Docket No.: 50-537

SUBJECT: REVISED EVALUATION OF ACCIDENTS FOR THE CRBR ENVIRONMENTAL  
 REVIEW

ACCIDENT EVALUATION BRANCH INPUT TO THE FINAL  
ENVIRONMENTAL STATEMENT UPDATE FOR  
CLINCH RIVER BREEDER REACTOR PLANT

Figure 7.1 Schematic outline of atmospheric pathway consequence model

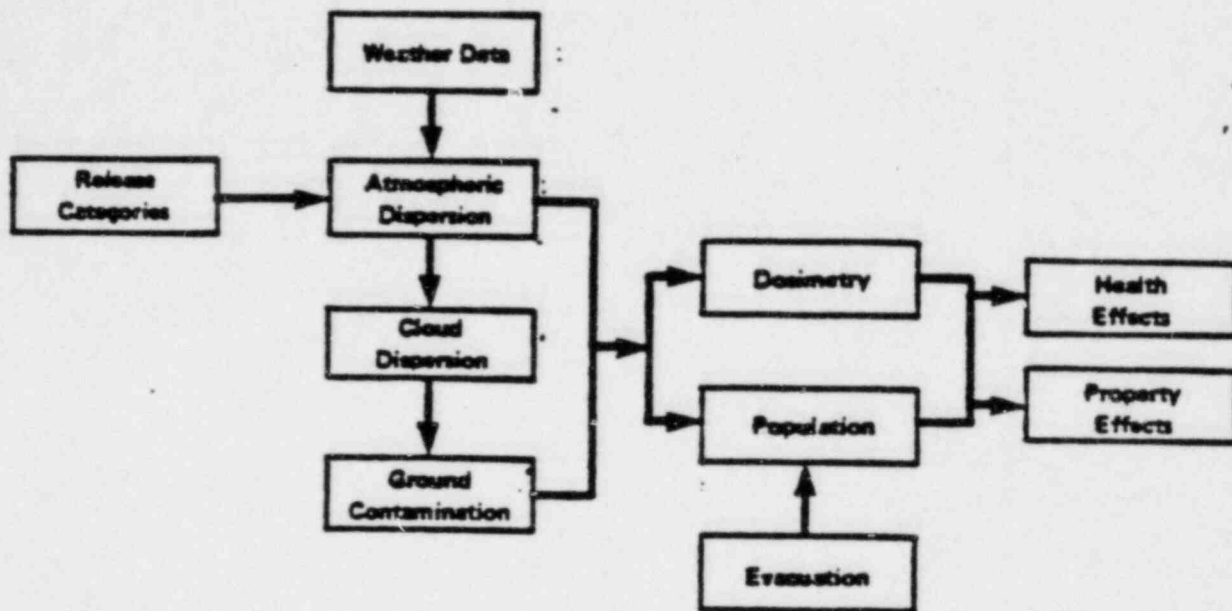
Figure <sup>J</sup>7.1 Schematic outline of atmospheric pathway consequence model
